3 Project changes

Cobbora Coal Project - Preferred Project Report and Response to Submissions

Figure 3.16

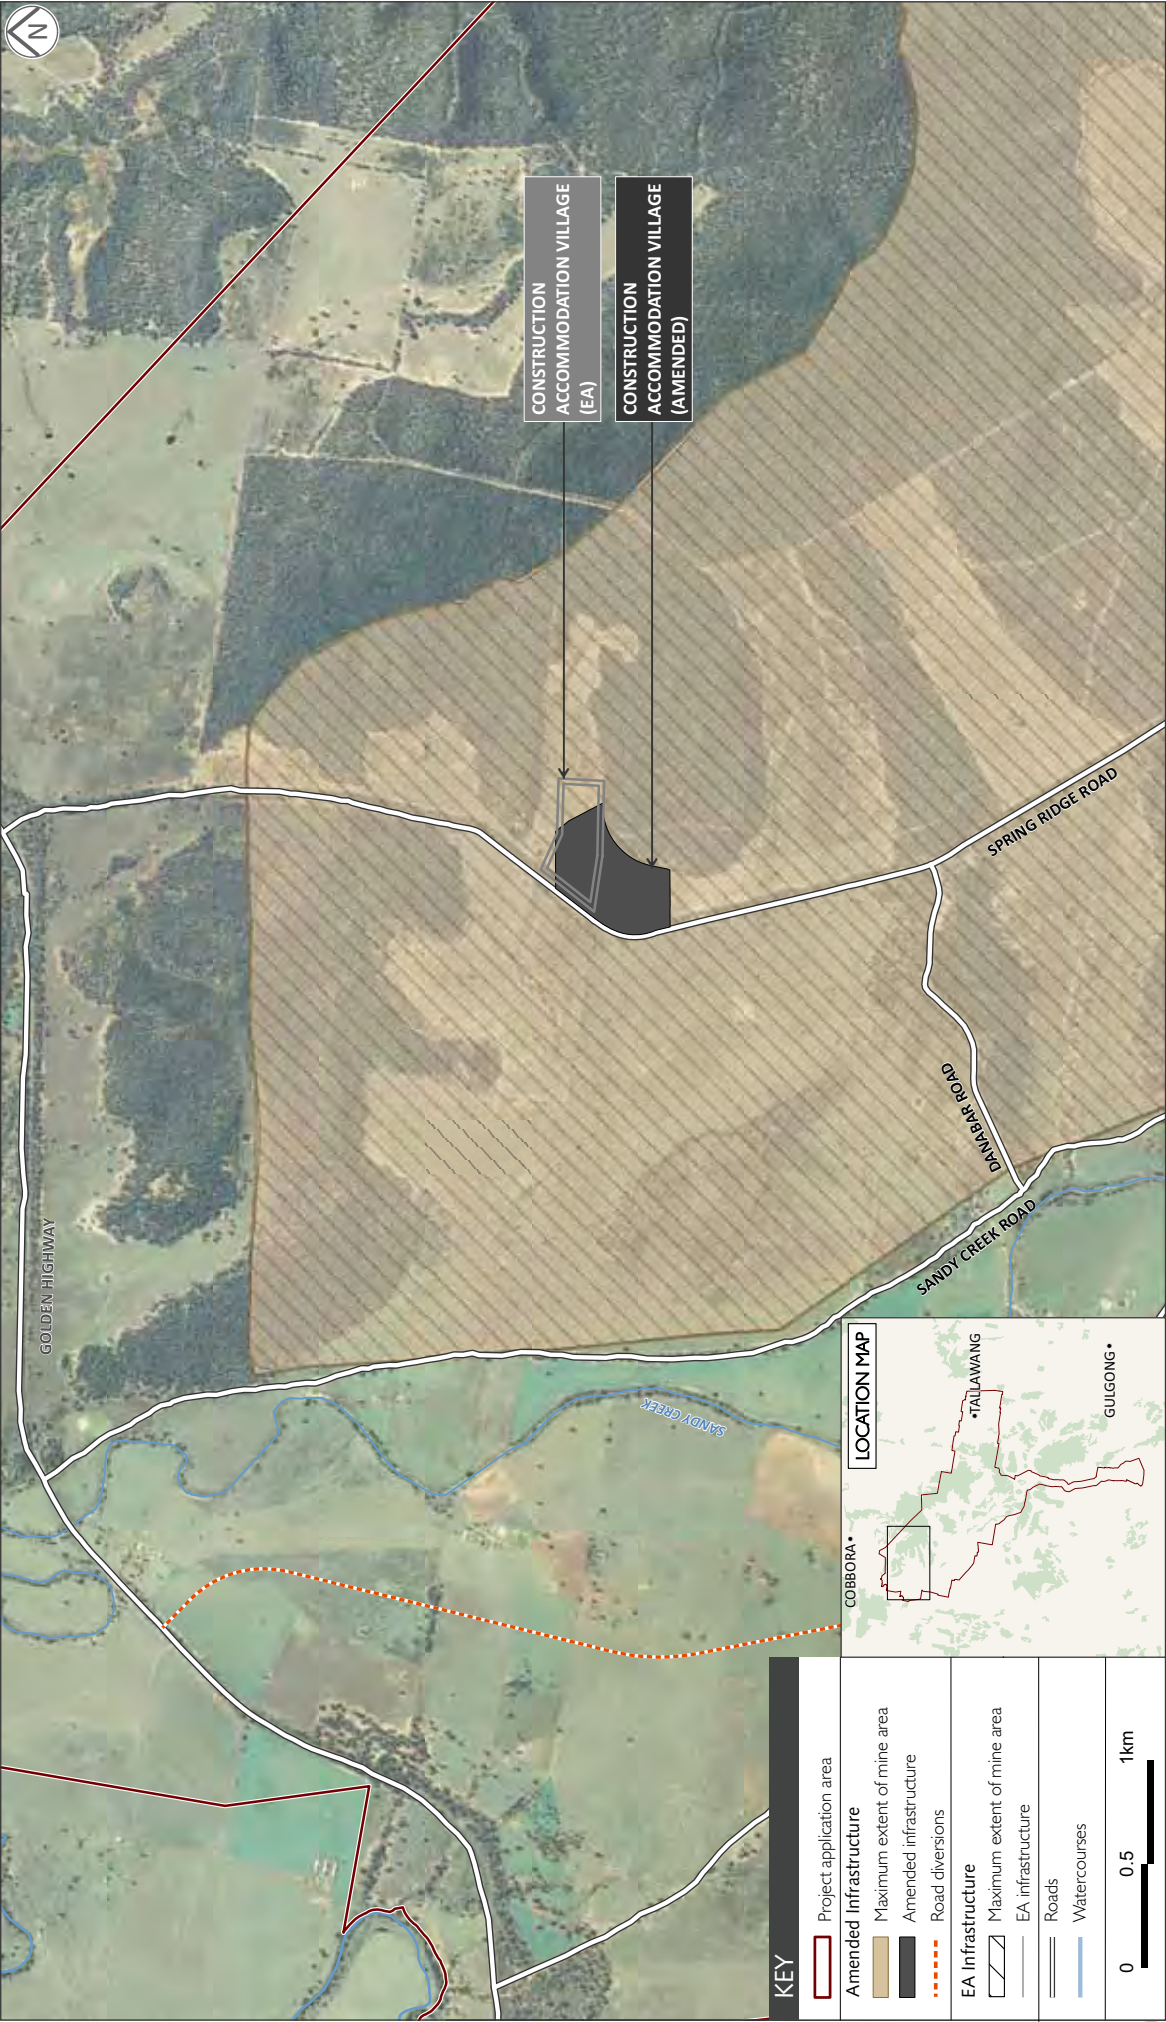
The footprint of the construction accommodation village is shown in the main EA (Figure 1.2). It is proposed to modify this footprint so that it extends further to the south (Figure 3.16) but it will remain within the larger footprint of the mine and will be removed following Project construction.
